Service Information Letter A-140 Rev. 1

Gear Driven Alternator Shipping Hardware

TRANSMITTAL SHEET

Figure 1 - Previous Shipping Hardware Installation

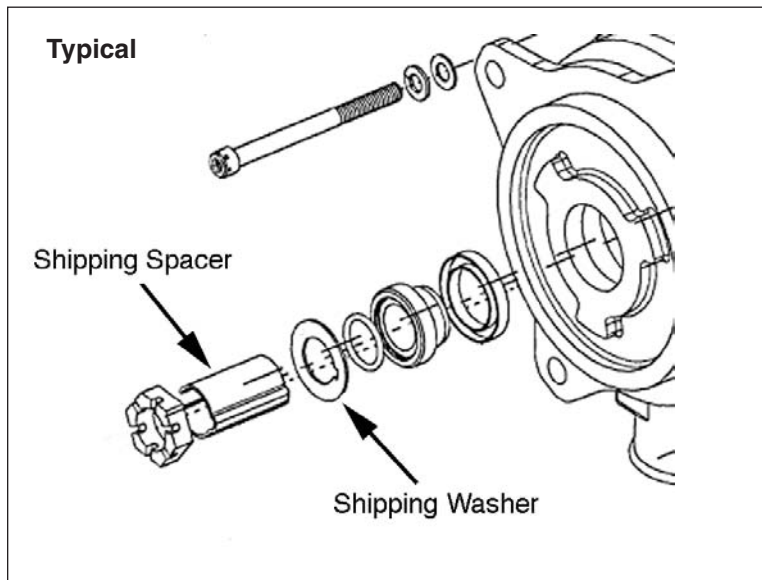
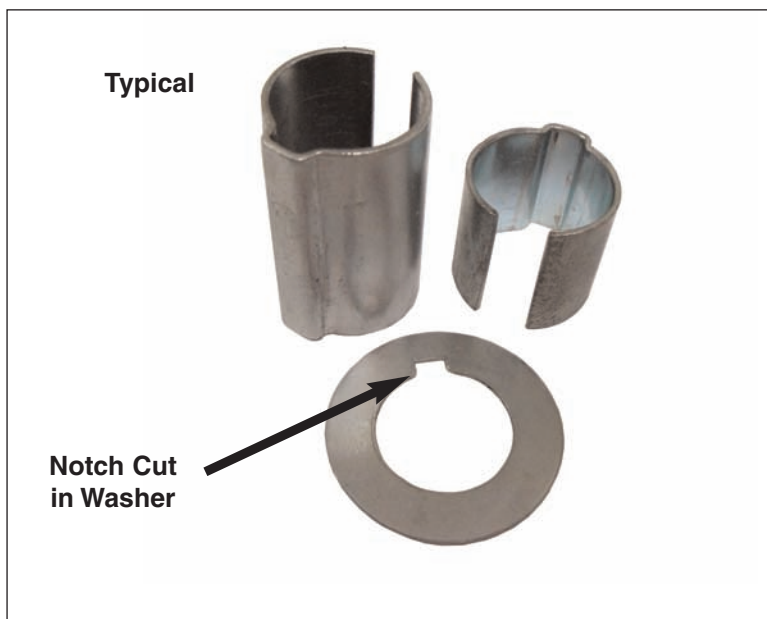
The Gear Driven Alternator Shipping Hardware shown in a previous revision of this Service Information Letter has changed.

NOTE: Alternators are currently shipped with non-metallic tubes as the shipping spacer and will not have a shipping washer. Existing alternator inventory may have a previous shipping hardware configuration.

Figure 3 - Phenolic Shipping Spacer & Metal Shipping Washer

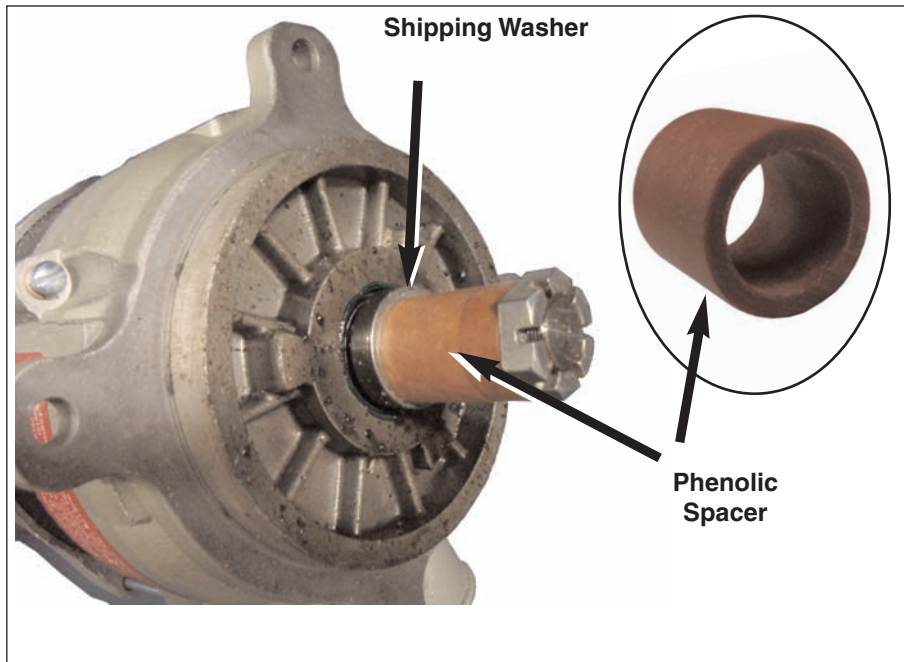
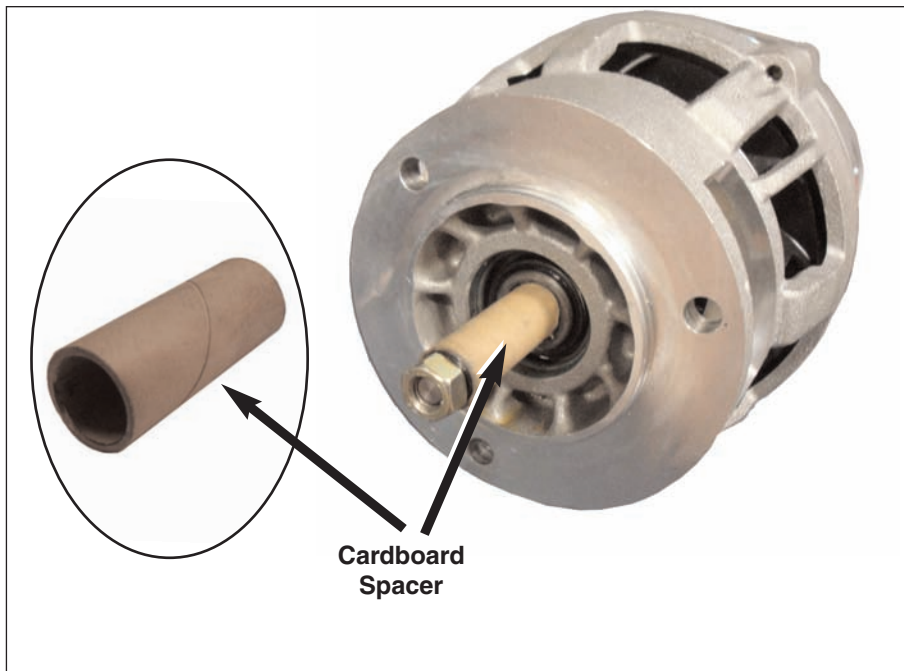
- (1) This publication provides Additional Maintenance Information (AMI).
- (2) This Service Information Letter is being issued to advise installers of gear driven alternators procured from HET for aircraft engines, that all shipping hardware must be removed and discarded prior to installation of the alternator drive coupling.
- (3) This Service Information Letter also announces that gear driven alternators are being shipped with a non-metallic shipping spacer and without a shipping washer. This method avoids confusion with alternator hardware. Refer to Figure 3 & 4 example.

- (2) All gear driven alternators are shipped with a shipping spacer.
 - (a) The shipping spacer may be a phenolic or cardboard tube fitted closely over the shaft and woodruff key, or a thin metal barrel formed to fit over the woodruff key with a slot on the opposite side. Discard this shipping spacer. Refer to Figure 2.
 - (b) If the shipping spacers are cardboard as shown in Figure 3 or phenolic type as shown in Figure 4, they may still have a metal shipping washer.

Figure 5 - ALV-9510 Alternator ONLY

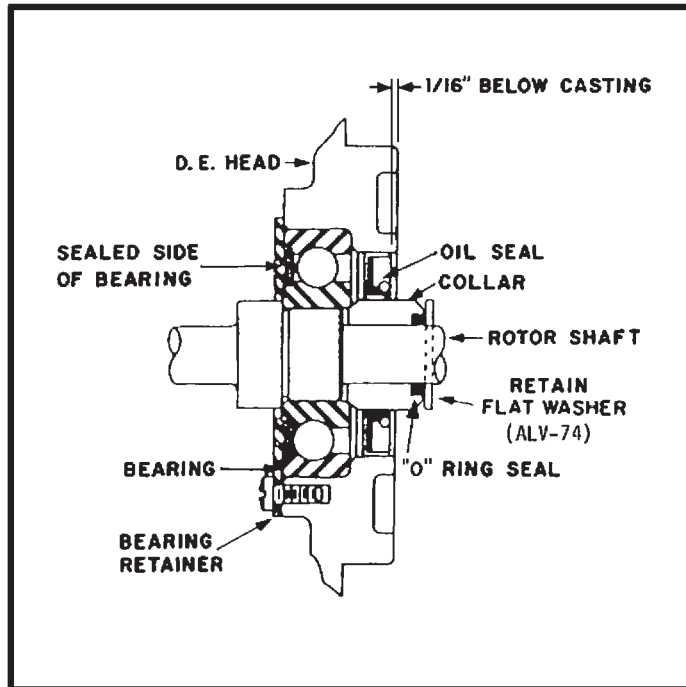
- (1) Gear driven alternators may or may not have a shipping washer included.
 - (a) Identify the shipping washer. These are all large thin washers with a notch cut in the inside diameter to allow the washer to slip over the woodruff key. Not all alternators will have a shipping washer included. Discard this washer prior to any installation work. (Refer to Figure 2).
 - (b) The ALV-9510R alternator (only) is shipped with an HET P/N ALV-74 washer located at the base of alternator drive shaft. This washer does not have a notch cut into it and must be retained to allow proper fit of the drive coupling. (The HET P/N ALV-74 is not a shipping washer.) Refer to Figure 5.
